Port of Gaspé – Sandy Beach Sediment Remediation Project

Environmental Impact Assessment filed with the with the Quebec Ministry of Sustainable Development, Environment, Wildlife and Parks (MDDEFP)

Addendum

September 2012
O/Ref.: 045-P001130-0162-EI-0200-00

Appendix 8 Figure 8, Revised

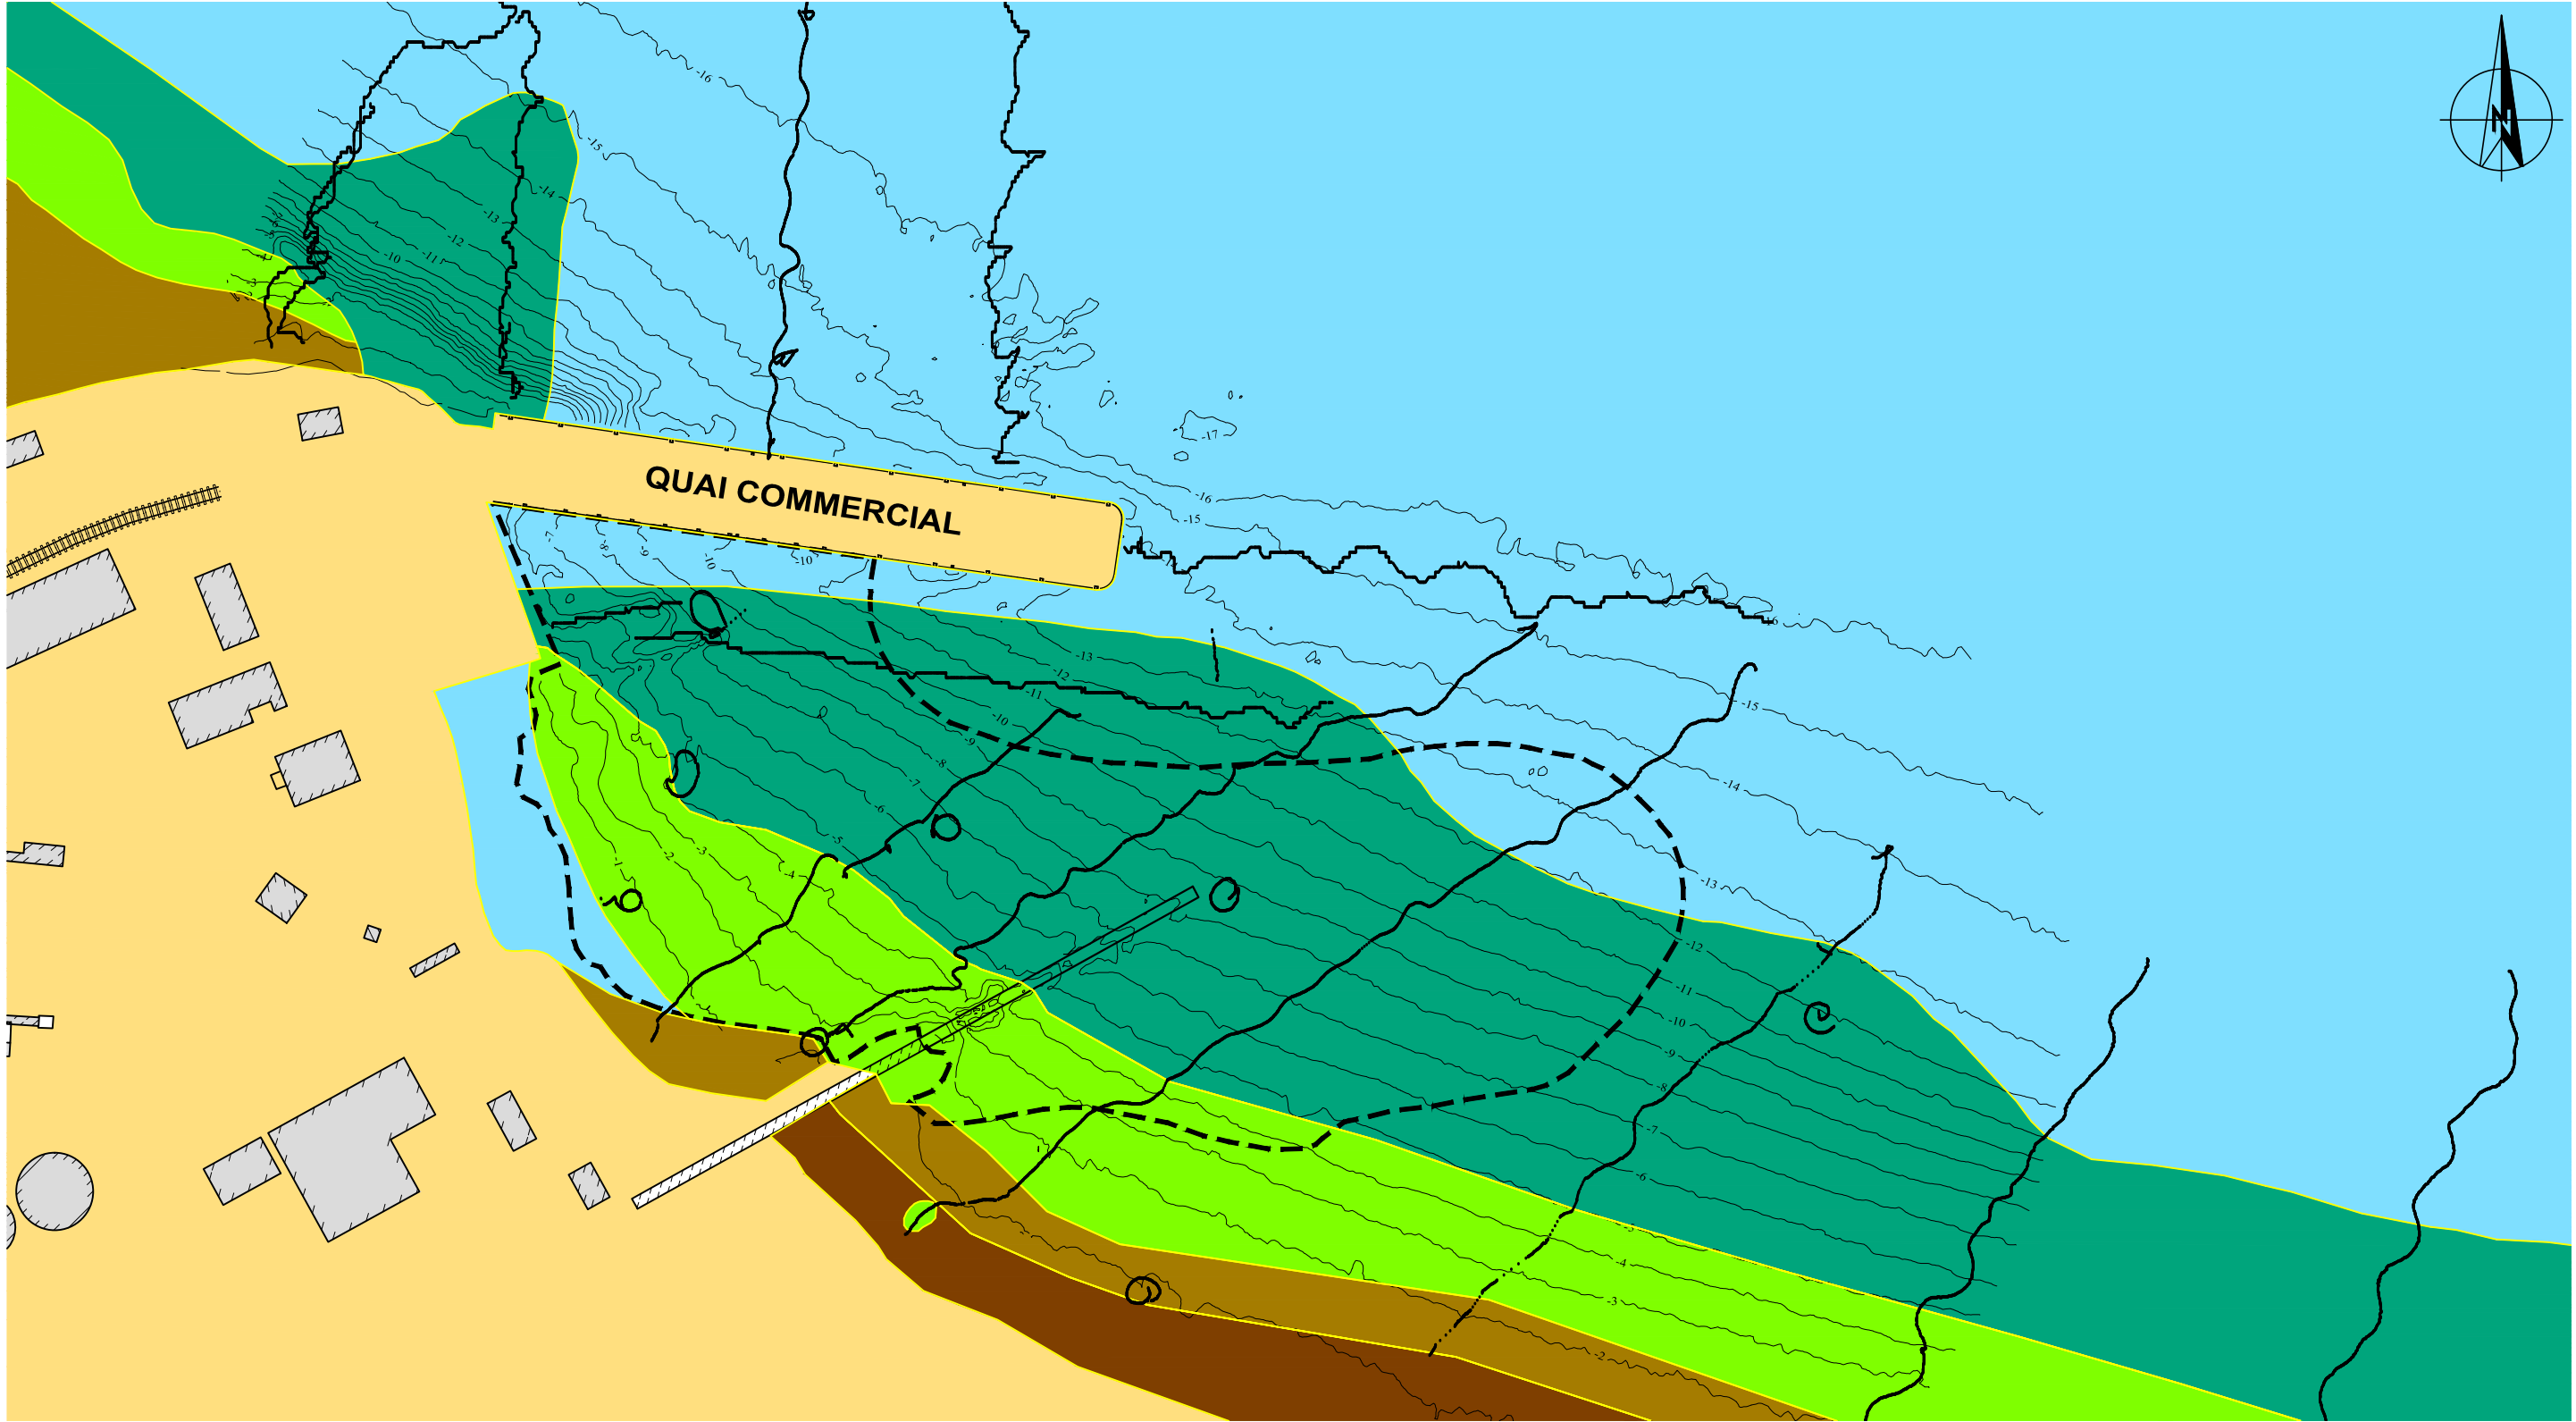
QC-33: The project proponent must indicate, on Figure 8, the camera transects used to map the seagrass beds and inventory the invertebrates.

The sea floor classification transects used to map the seagrass beds and inventory the invertebrates are shown on revised Figure 8 in Appendix 8.

Appendix 12 SPM Dispersal Plume

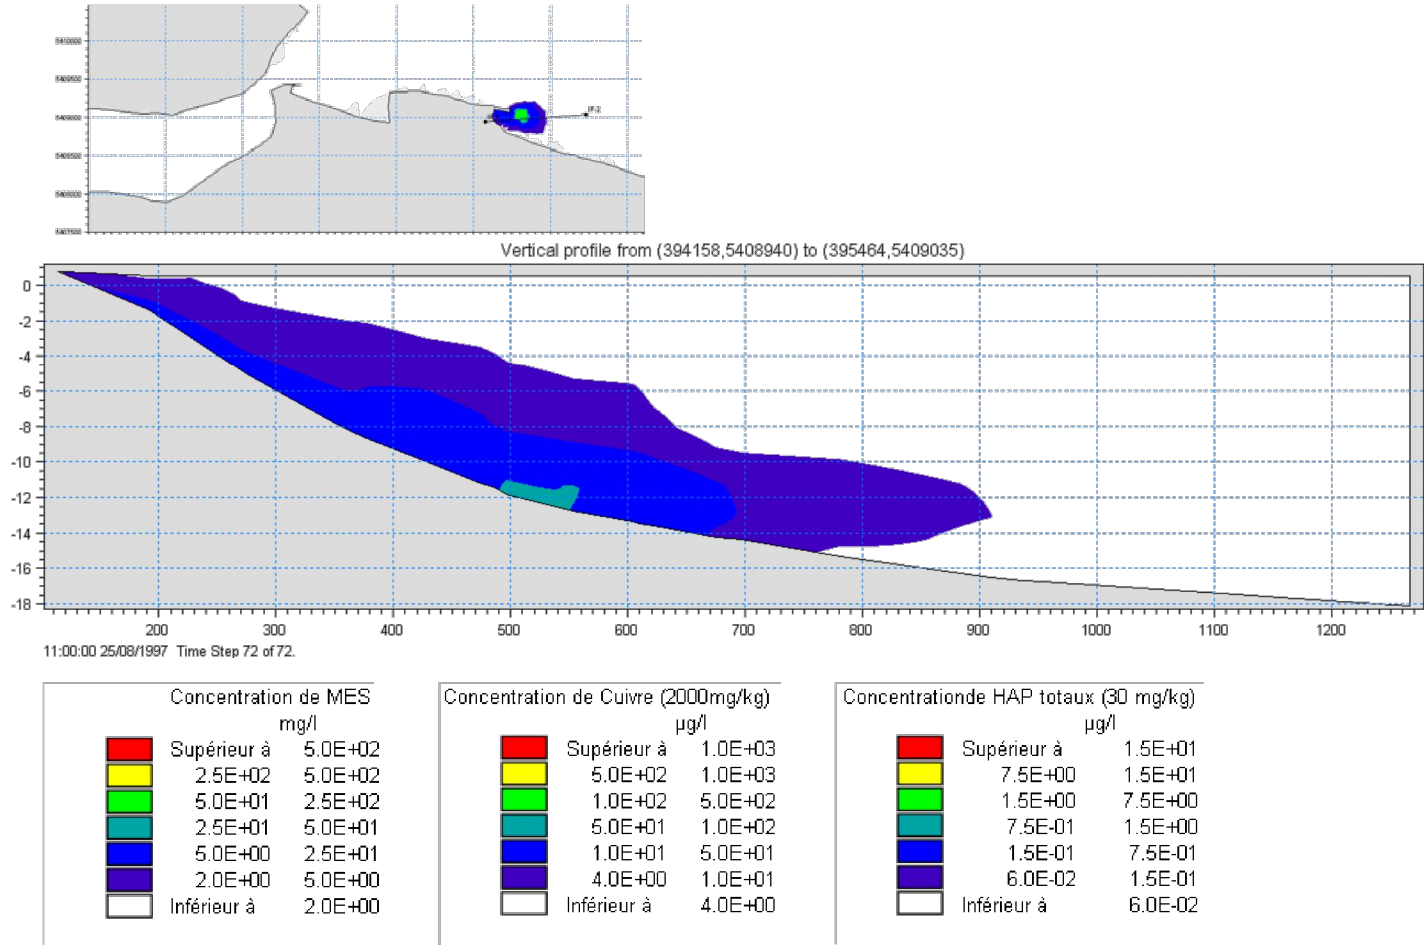
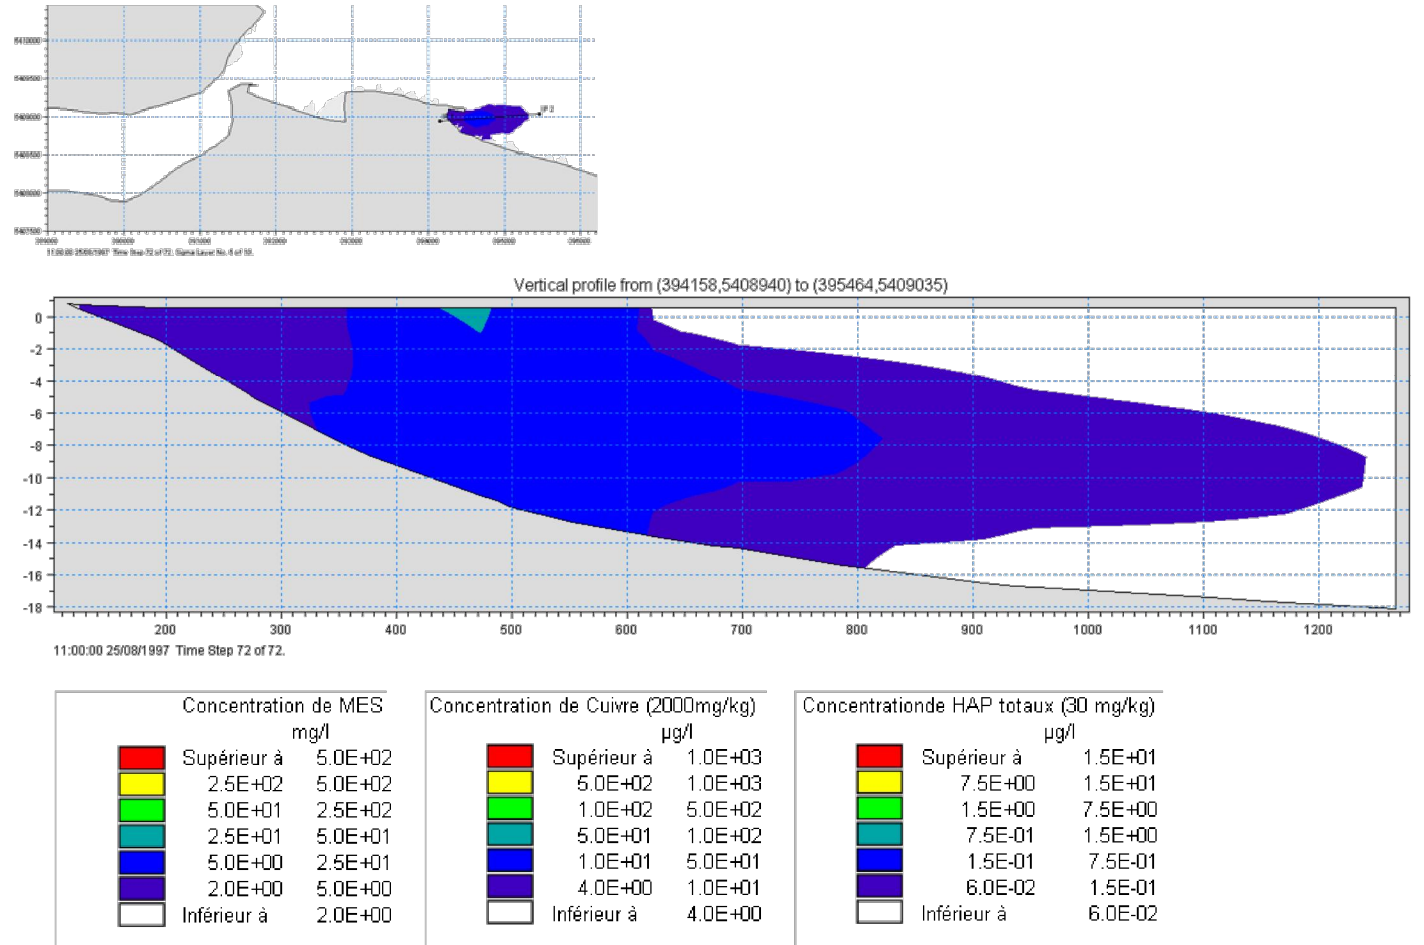
QC-40: Based on the sediment hydrodynamic studies conducted by Environnement Illimité (2005) and Groupe-Conseil Lasalle inc. (2010) (see Section 5.1.10), the project proponent must indicate, in a figure, the SPM dispersal plumes according to the type of dredge used (mechanical or hydraulic) and indicate the SPM concentrations that could be observed 50, 100 and 300 metres from the dredge. The proponent must also illustrate how a turbidity curtain or bubble curtain could be positioned to keep SPM dispersal to a minimum.

The figure presented in Appendix 12 illustrates the plumes as modeled by Groupe-Conseil LaSalle (2010) for hydraulic dredging and mechanical dredging.

Furthermore, the Contractor will be required to take the necessary steps to ensure that the plume generated by the work does not increase the ambient SPM concentration by more than 30 mg/l at this parameter's control point (150 m downstream of the dredging equipment or the turbidity curtain as described in the Protocol). The figure in Appendix 3 indicates the potential placement of a conventional turbidity curtain. Installing a turbidity curtain will be mandatory for Zone A (see Appendix 2), the most contaminated zone. For the other zones, the installation of a curtain or any other structure or method approved by TC will be at the Contractor's discretion. The Contractor can install the curtain another way, as long as the water quality monitoring criteria is respected.
